BURLINGTON DEVELOPMENT REVIEW BOARD

MEMORANDUM

To: Development Review Board
From: Mary O'Neil, AICP, Principal Planner
Date: ~~August 7, 2018~~ September 4, 2018
RE: ZP18-0975CA and ZP

Project Number: ZP18-0975CA; 18-0976LL (308 Main) and 18-0977LL (323-325 College)

Not Approved for Construction
Drawing Title
Proposed Site Plan

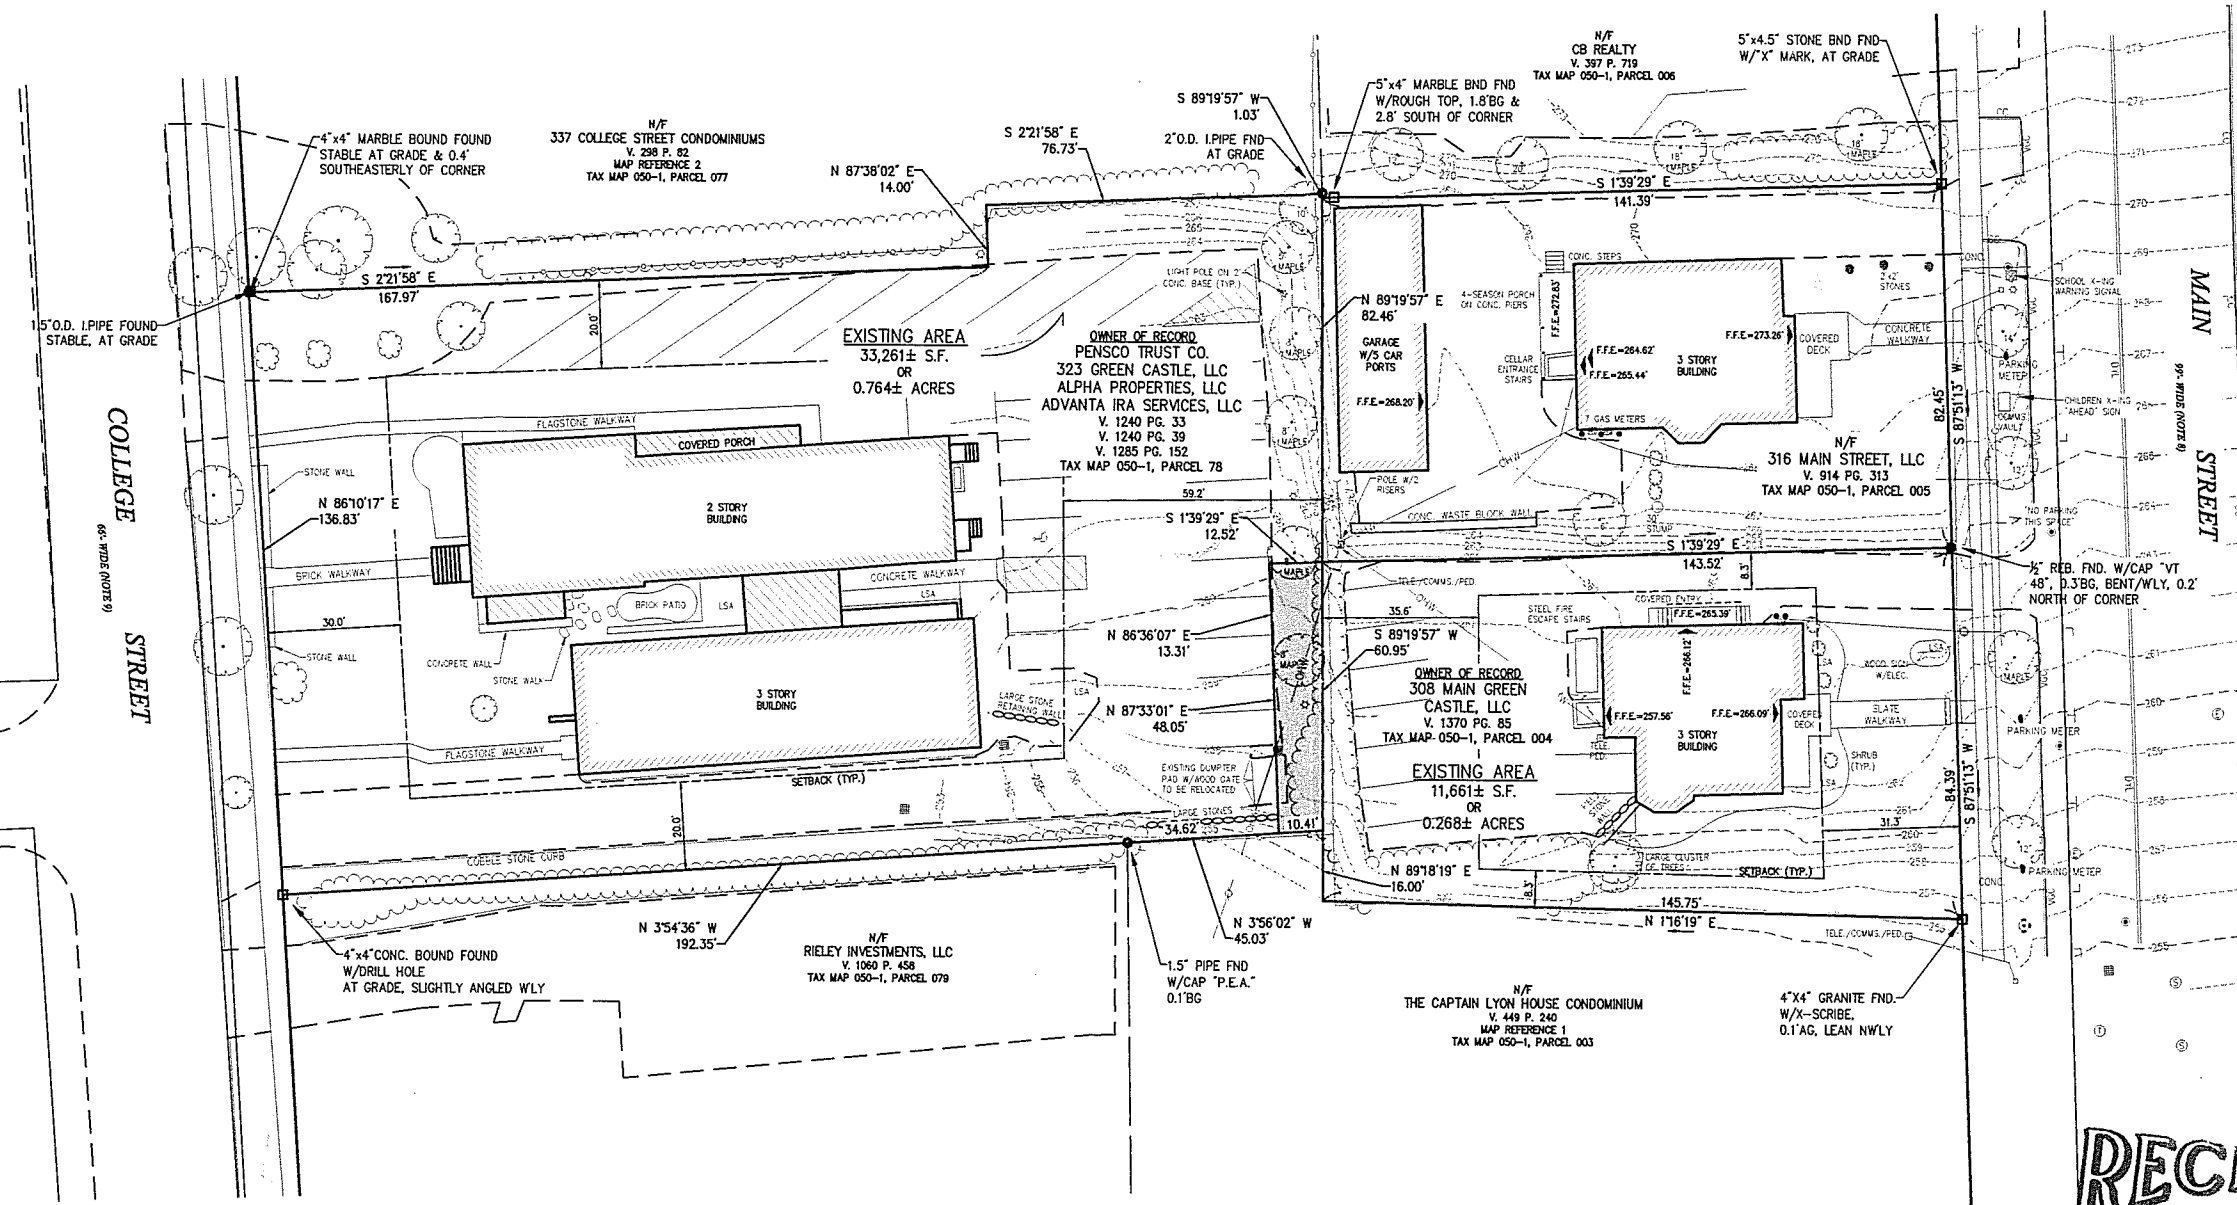
The re-located dumpster, and the westerly parking space at 308 Main Street meet the required 5' minimum setback. See plan C1.00.

Landscaping is proposed in front of (north) a newly proposed parking space on the west of the driveway at 323-325 College Street. As this space does not meet the required placement defined in 4.4.5 (a), it is recommended for removal from the plan.

The revised site plan places three + two additional parking spaces on the rear/west side of 323-325 College Street at a location of a catch basin. (See Plan C-100.) The alteration of the stormwater feature is subject to review and approval of the Stormwater Engineering team.

A new concrete sidewalk is proposed from the easterly side of 308 Main Street to the rear entrance. (Plan C-100.) This will allow building residents to exit directly onto a pathway that will lead around the building toward the public sidewalk on Main Street.

The new parking space proposed for the northwesterly part of 323-325 College Street is not situated at the rear, within, or at the side of the building as required by 4.4.5 (a). It is therefore unacceptable as proposed. It would provide a 43rd parking space, when only 42 are required to meet the parking standards for both properties. As such, it is superfluous and its loss uneventful. As noted, the intended vehicular circulation path must be defined.

Seven shrubs are proposed for the west elevation of 308 Main Street (see Plan C-1.00) which is likely to help to visually screen the proposed parking expansion, particularly the new compact space.

4. Impact Fees must be paid within thirty (3) days of issuance of the building permit.
5. The parking space west of the driveway at 323-325 College Street does not meet the standard to provide parking *either behind, within, or to the side of structures* as defined in Section 4.4.5 (a), and shall be removed from the site plan.

① EAST ELEVATION
3/16" = 1'-0"

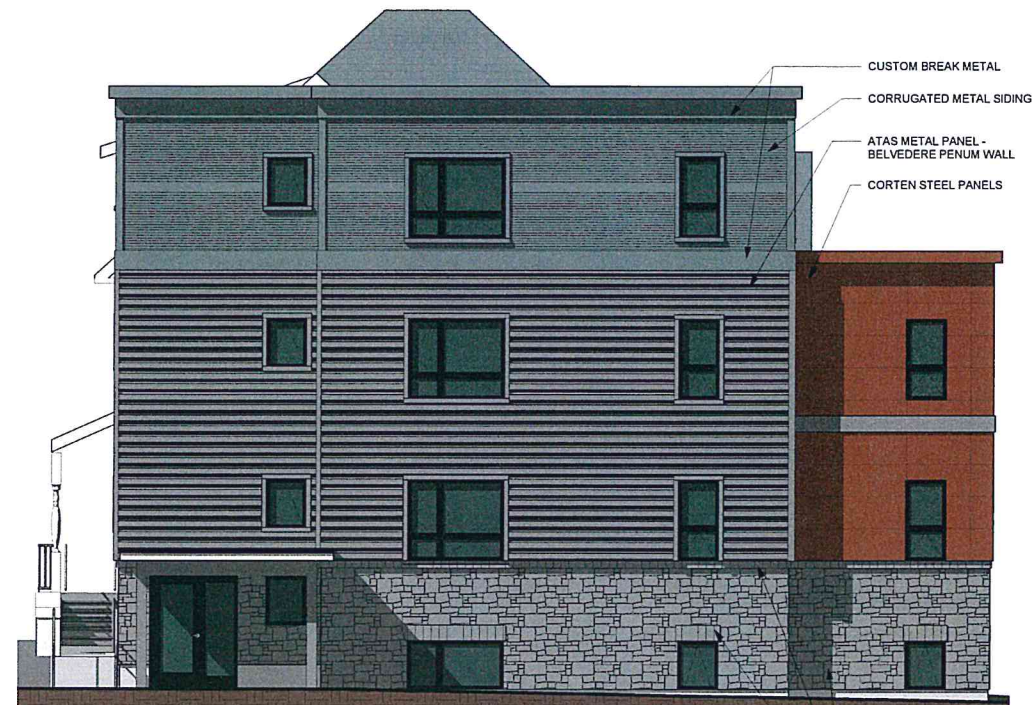
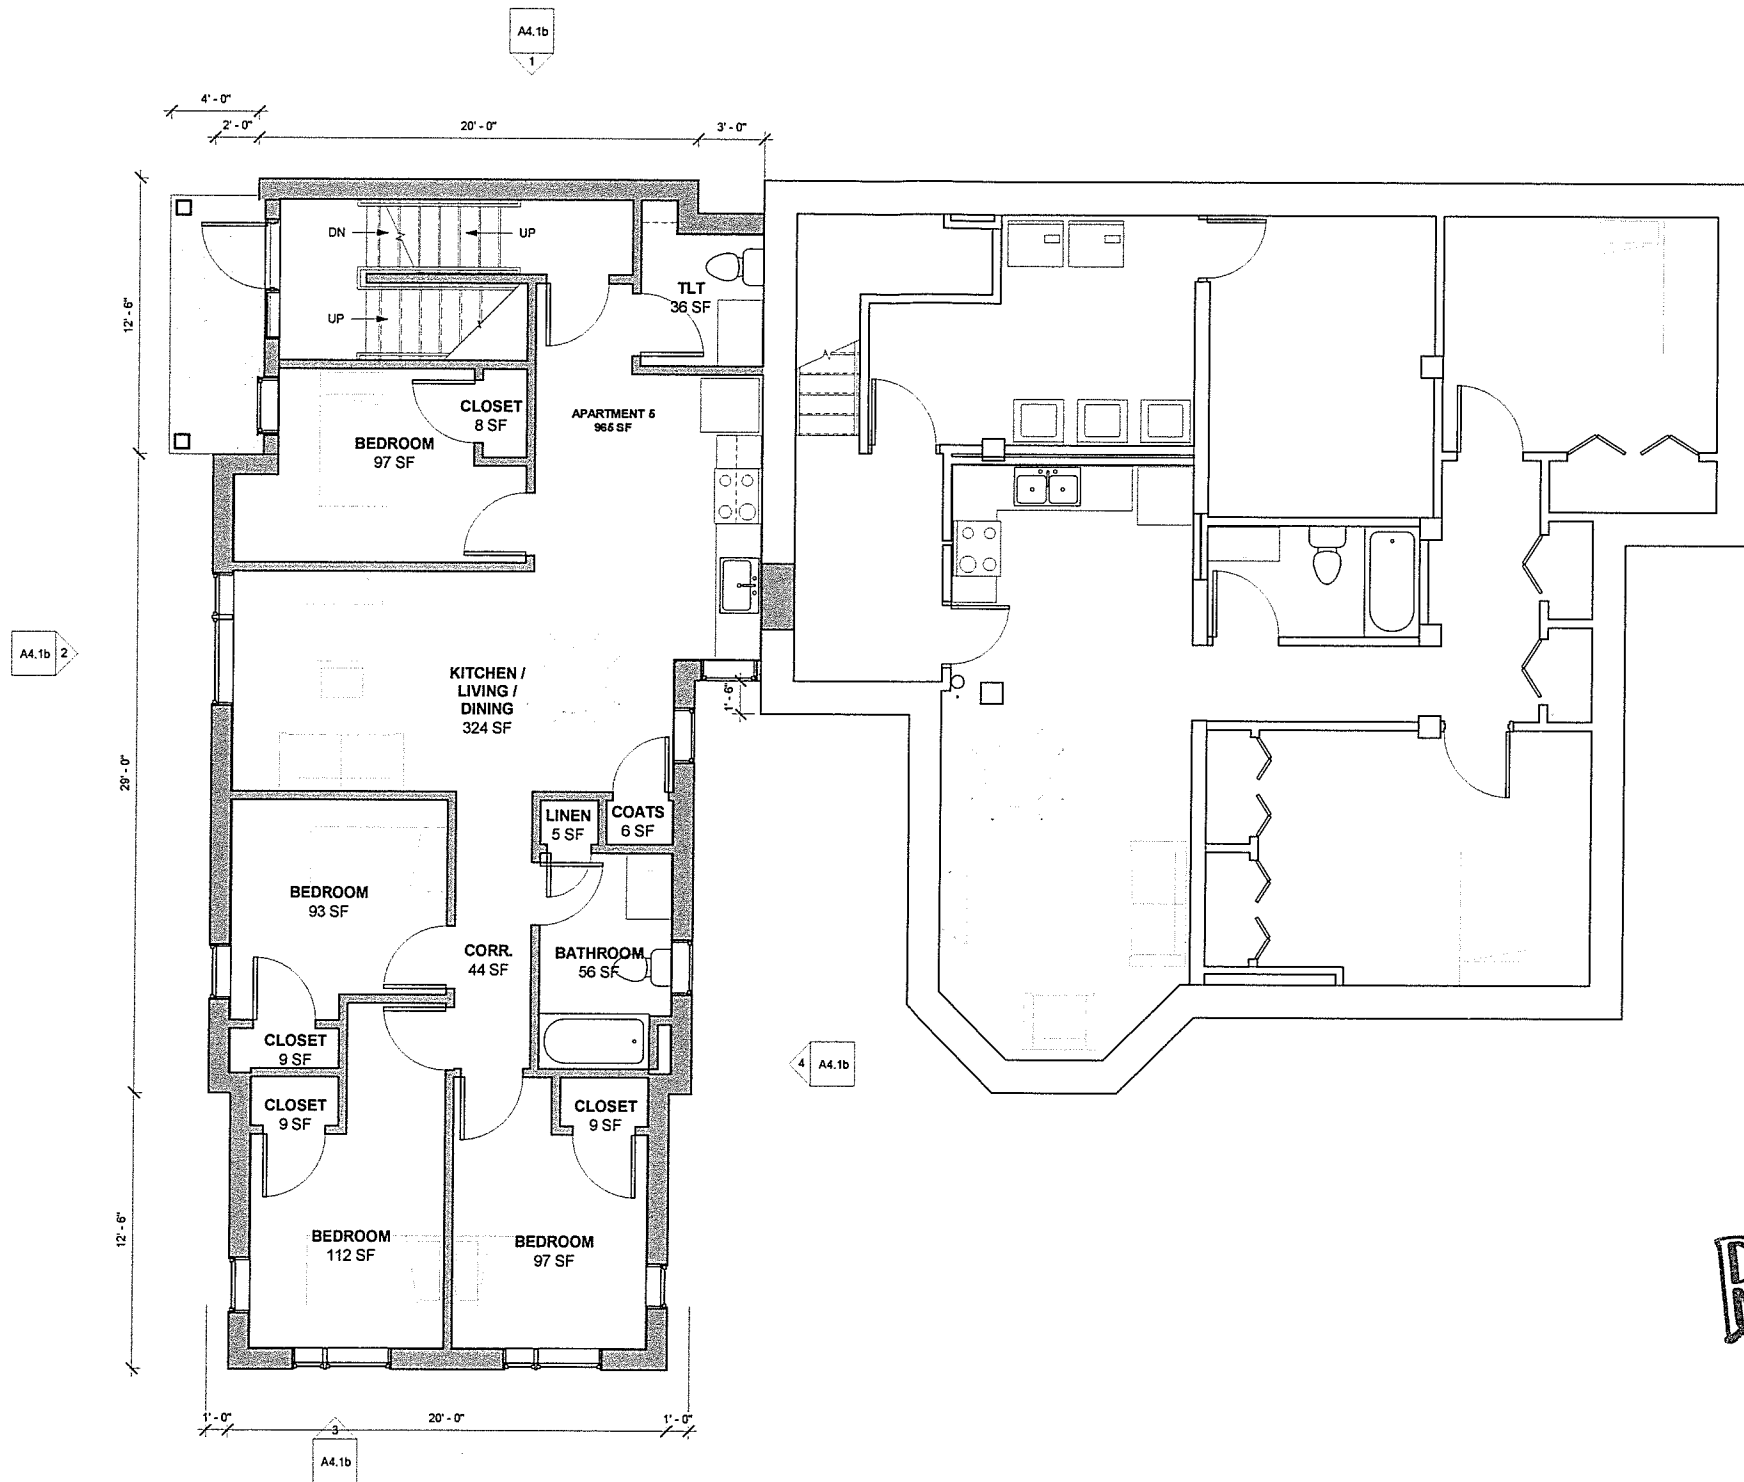
1. If option A is chosen, corner boards shall be either simplified or removed. (Option A was the originally proposed plan and is not now before the DRB.)
2. Windows shall be un-ganged on the south elevation,
3. The applicant shall explore un-ganging the windows on the west elevation.
4. The location of mailboxes shall be defined.

The addition as visible from the public right-of-way has been modified to minimize visual impact with the existing historic structure. Windows are placed in horizontal alignment with the floor levels of the existing structure. The stone foundation is referenced in the masonry veneer proposed for the lower level of the addition. **Affirmative finding.**
